EH-PLANS-26-0

EnvHealth/Environmental Health/Plan Check/Application

SFD/ CONSTRUCT 15 X 32 (1) STORY ATTACHED GARAGE/, 1 STORY, Slab on Grade, 1R, 0FB, 0HB, 0FP, OTHER STRUCTURE = Attached Garage, 0BR, PORCH/DECK = N/A, ENERGY METHOD = Prescriptive Method,

From: Oswald Jr, Woodin
Sent: Wednesday, January 7, 2026 10:52 AM
To: 'SPORTA@VERIZON.NET'
Cc: 'jasonfermite@icloud.com'
Subject: B25005342_2621 Melba Road_Plan Review Comments
Attachments: County Waiver Form interactive_Perc Cert Plan Requirements.pdf

Lot 18

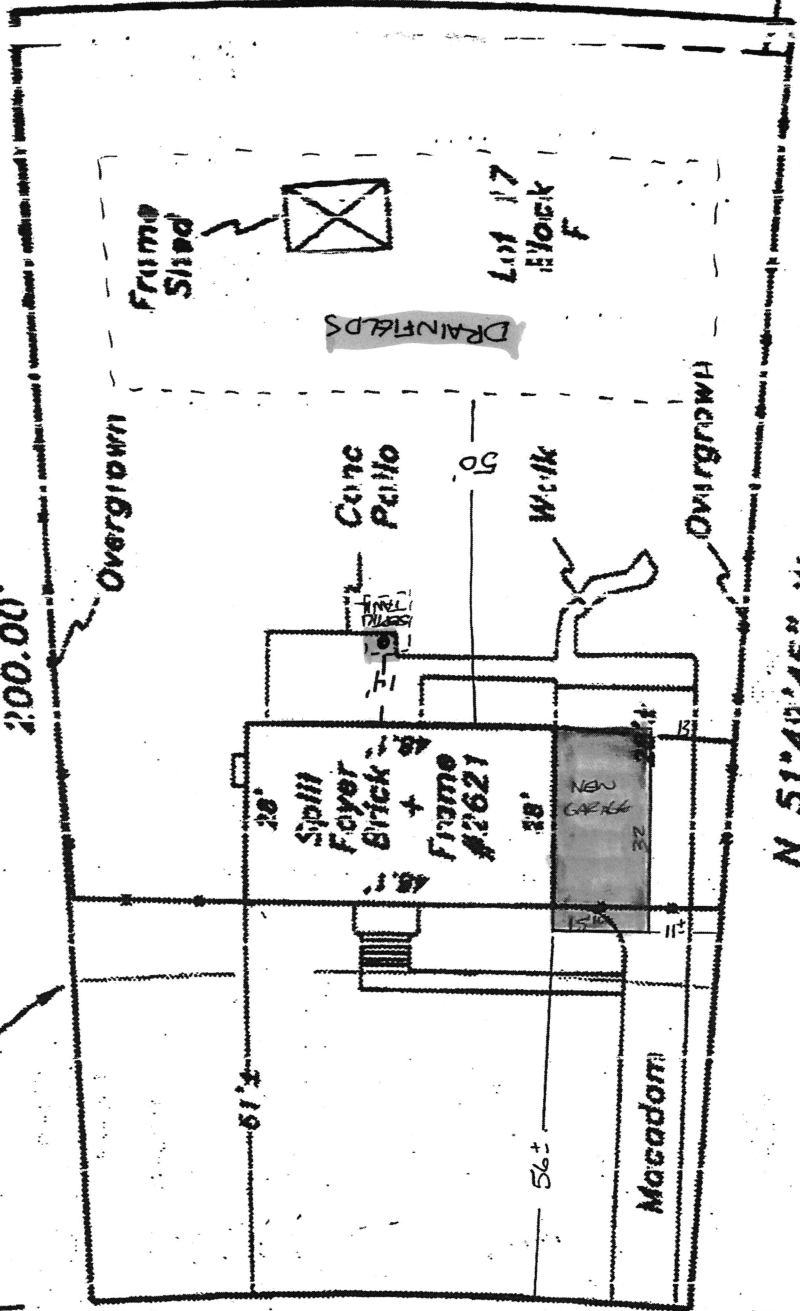
Good morning. In review of the building permit for a garage addition located at 2621 Melba Road, the site plan did not include the location of the septic system components. Please revise the site plan to include these components and resubmit to DILP. In addition, the proposed garage addition triggers the perc cert plan requirements. Since public sewer is available in the road, the homeowner may ask for a waiver by completing/signing the attached form. I will need to conduct a site visit as soon as the location of the components are identified on the site plan. If the homeowner cannot provide these details, a septic contractor should be consulted. If the septic tank hasn't been pumped in a while, this may be a good time to have that done.

LOCATION DIAGRAM

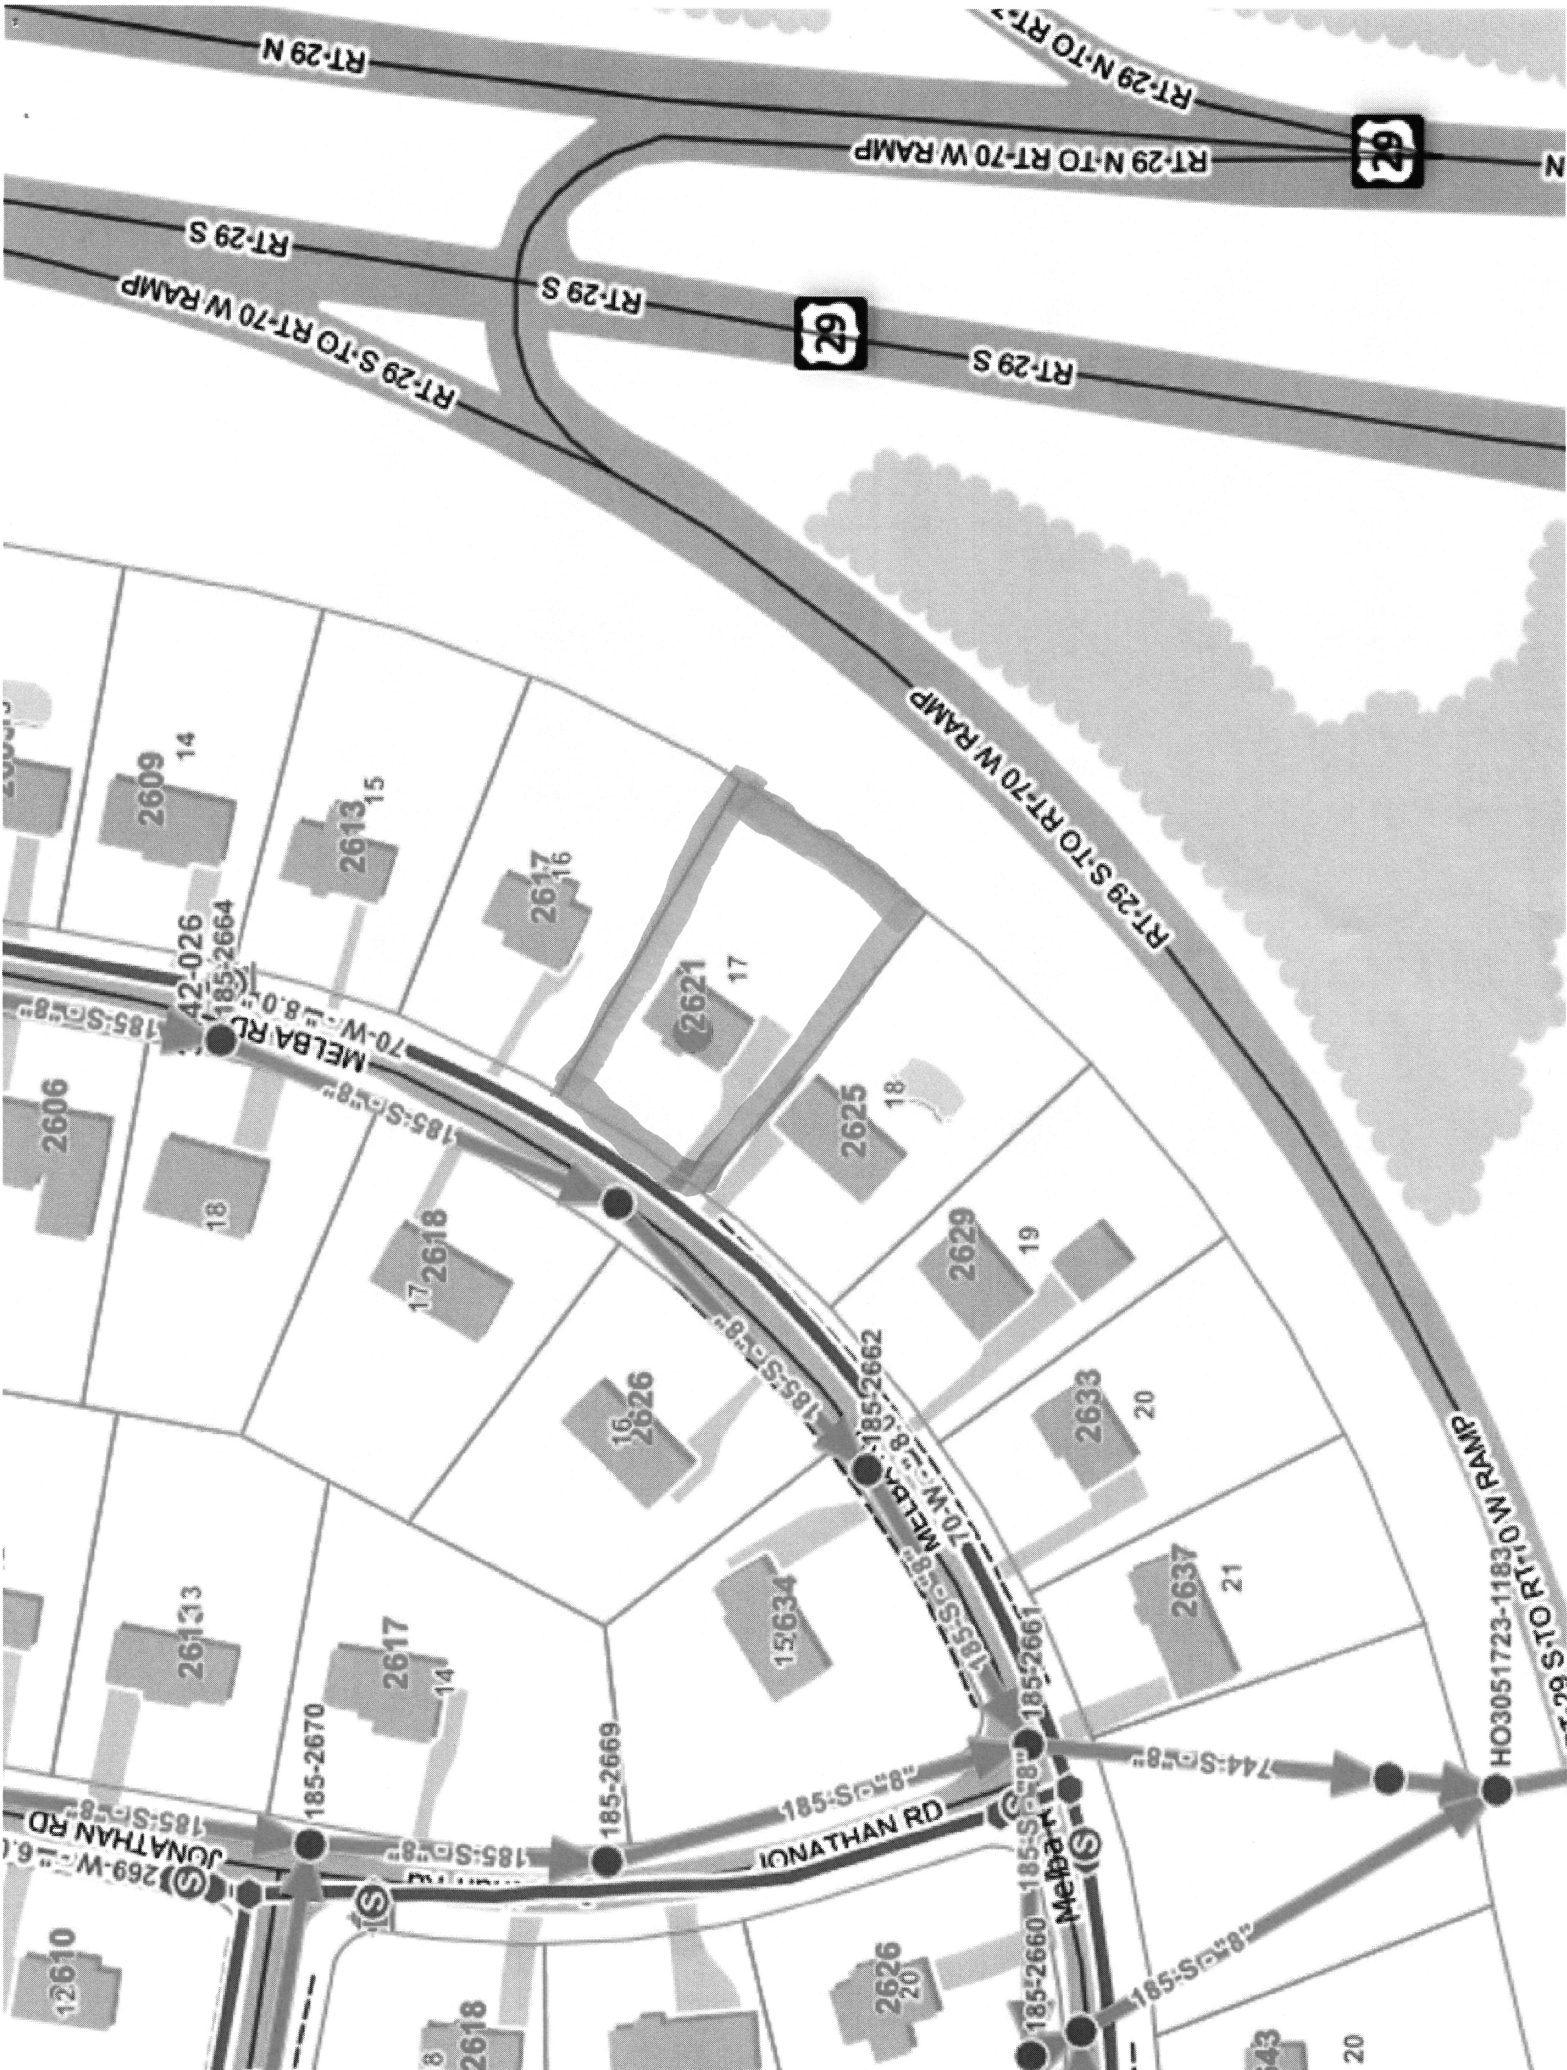
COMMENTS: No observed issues w/ the septic system.
